Planning Commission Meeting

4.I. 417 Walnut Street Site Plan Review

**DEPARTMENT OF PLANNING AND ZONING
PLANNER'S REPORT**

DATE: September 2, 2020
 TO: Adrienne Senter
 FROM: Lynn Patterson
 RE: Site Plan Review – 417 Walnut Street

HOUSE LOCATION PLAN FOR:
417 WALNUT STREET

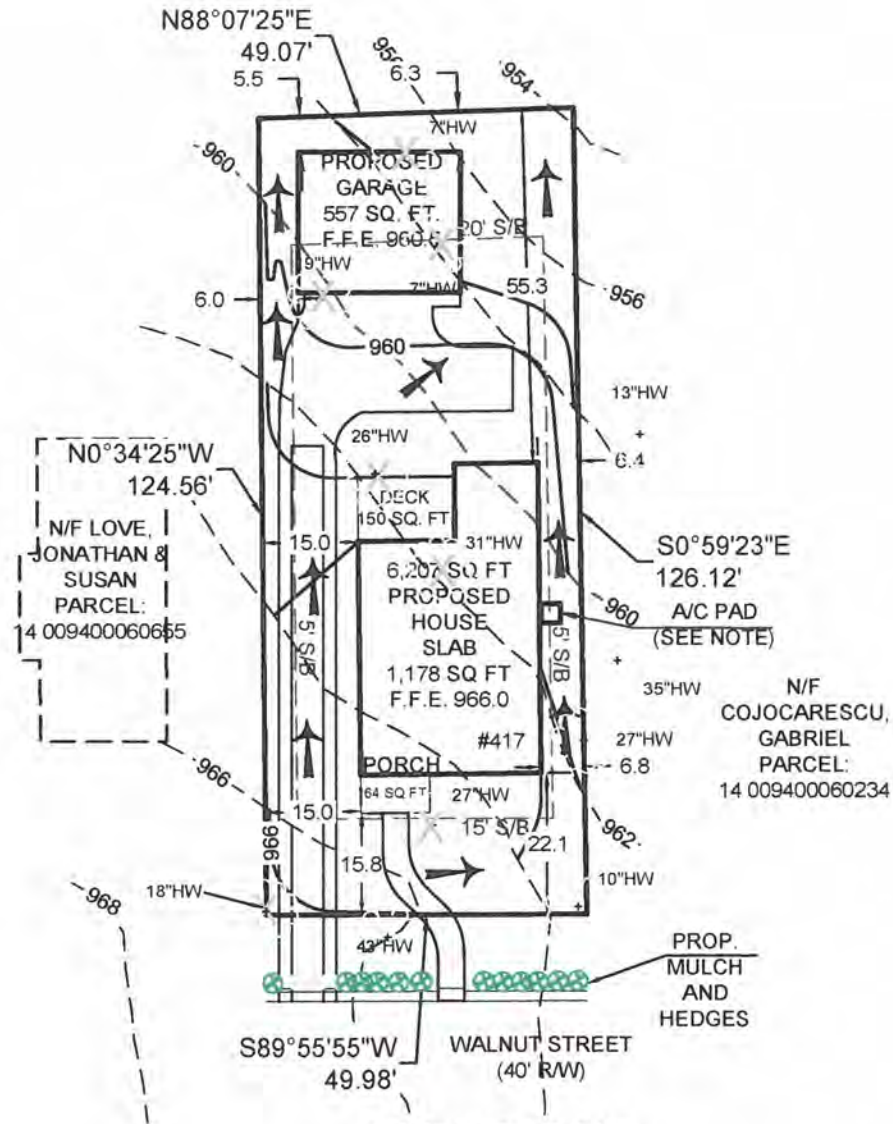
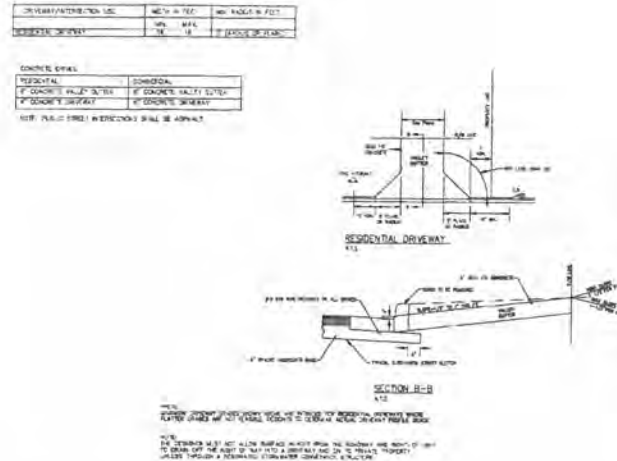
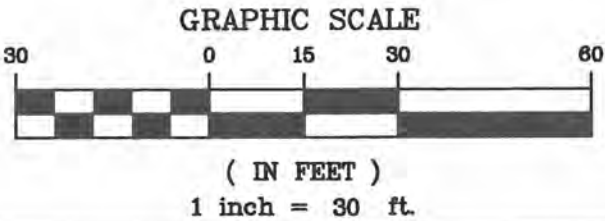
- ***The plans include a proposed driveway but does not indicate the width. The applicant should indicate the width of the proposed driveway and curb cut.***

- ***The plans do not include a new sidewalk with landscape zone.***
 - ***The plans include a walkway from the entrance to the street.***
 - c. The locations, area and number of proposed parking spaces.

- f. Number of parking spaces and area of paved surface for parking and circulation.
- ***Parking will be provided by a two-car garage in the rear of the dwelling, connected to the street by a driveway with a turnaround area. The applicant should provide the width of the driveway.***

The proposed garage is setback between 5.5' and 6.3' from the rear lot line.

The distance between the proposed garage and the principal dwelling should be indicated.

- The applicant should indicate the width of the proposed driveway and curb cut.
- The applicant should address the absence of a sidewalk on the plans.
- The applicant should indicate distance to the primary dwelling and any other buildings, including outbuildings on adjacent properties.
- The applicant should provide a development schedule.
- The applicant should address any outstanding issues related to the tree conservation plan as presented by the City arborist report.

Tree Conservation Plan

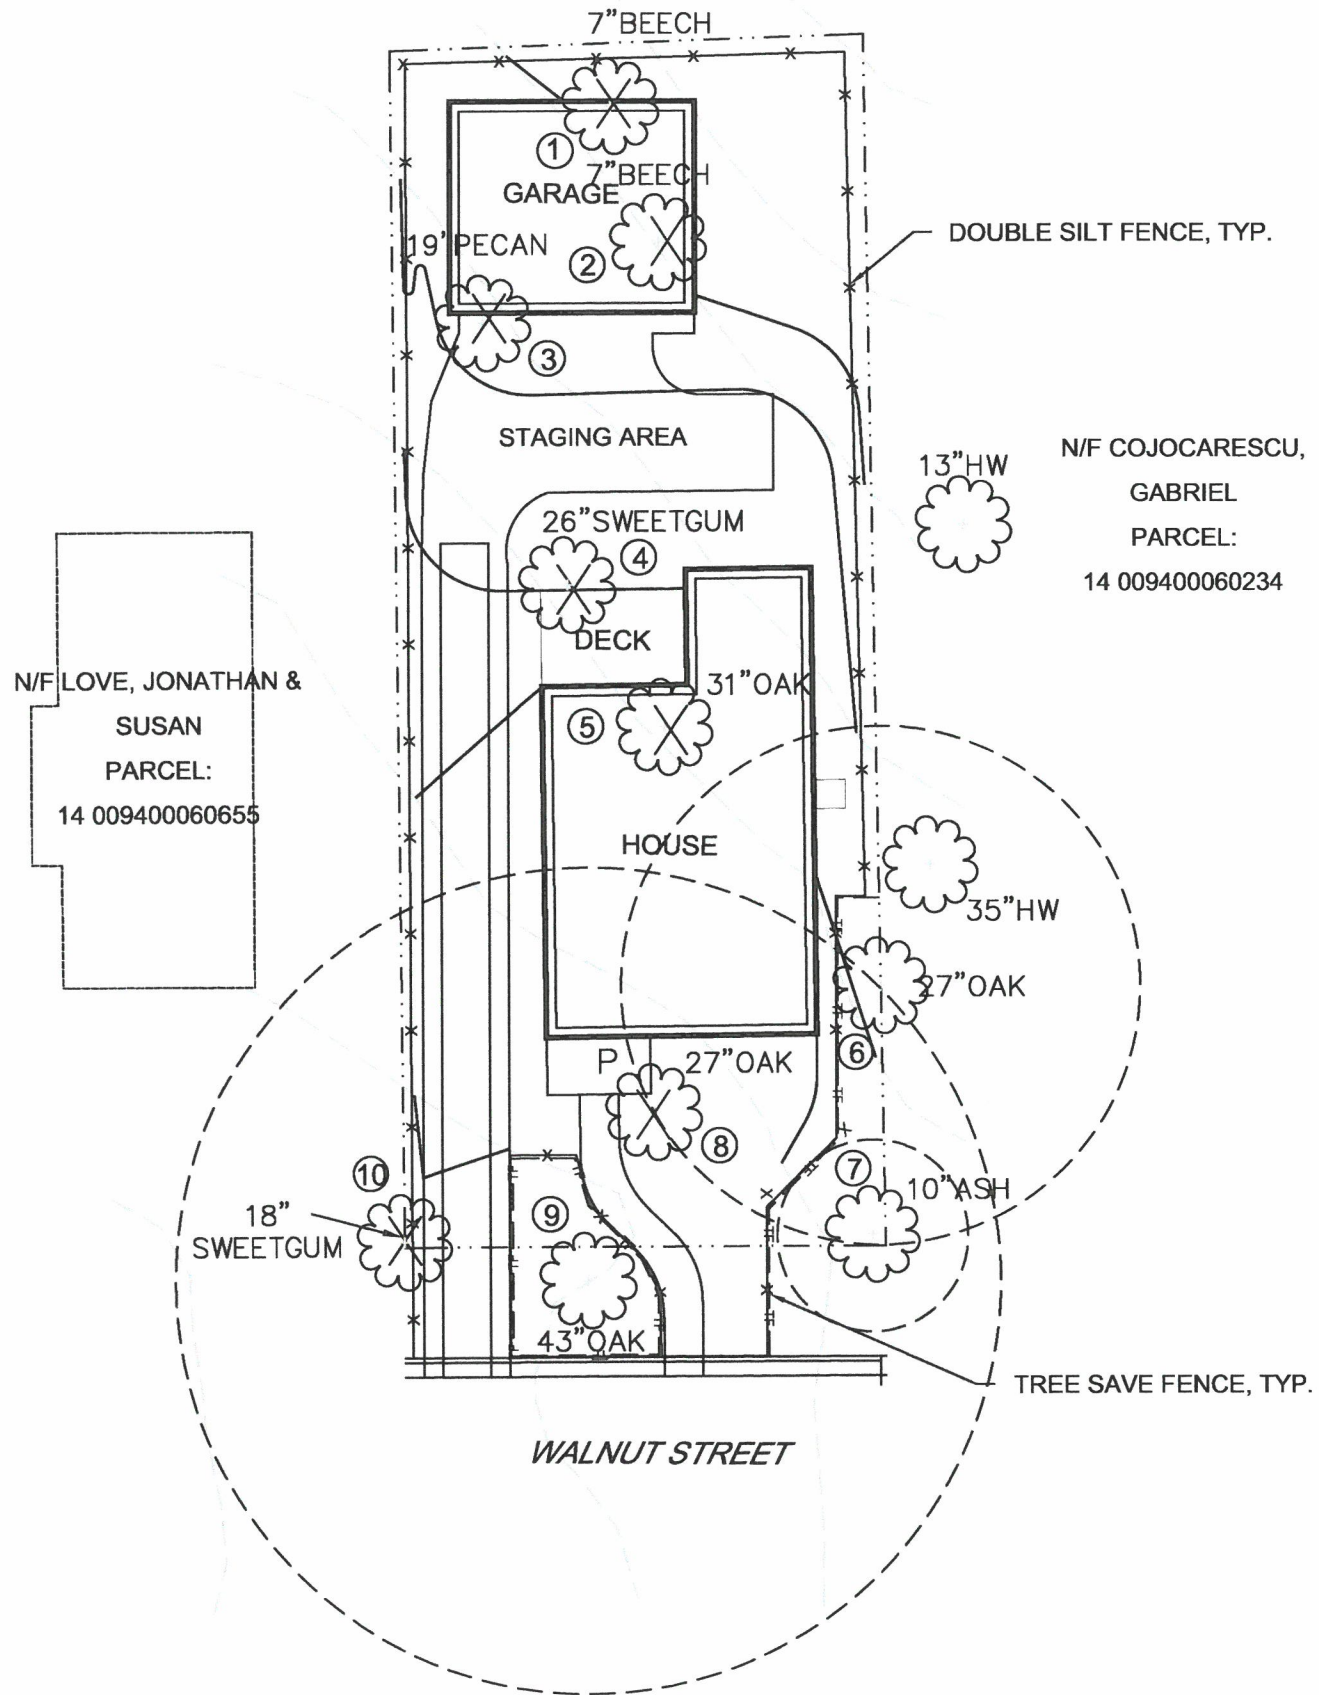
- ***The plans indicated 10 trees over 6" caliper onsite: 7" Beech (removed), 7" Beech (removed), 19" Pecan (removed), 26" Sweetgum (removed), 31" Oak Landmark (removed), 27" Oak (Preserved), 10" Ash (preserved), 27" Oak Landmark (removed), 43" Oak Landmark (preserved), 18" Sweetgum (removed).) The arborist report indicates the 31" Oak is in Poor condition.***
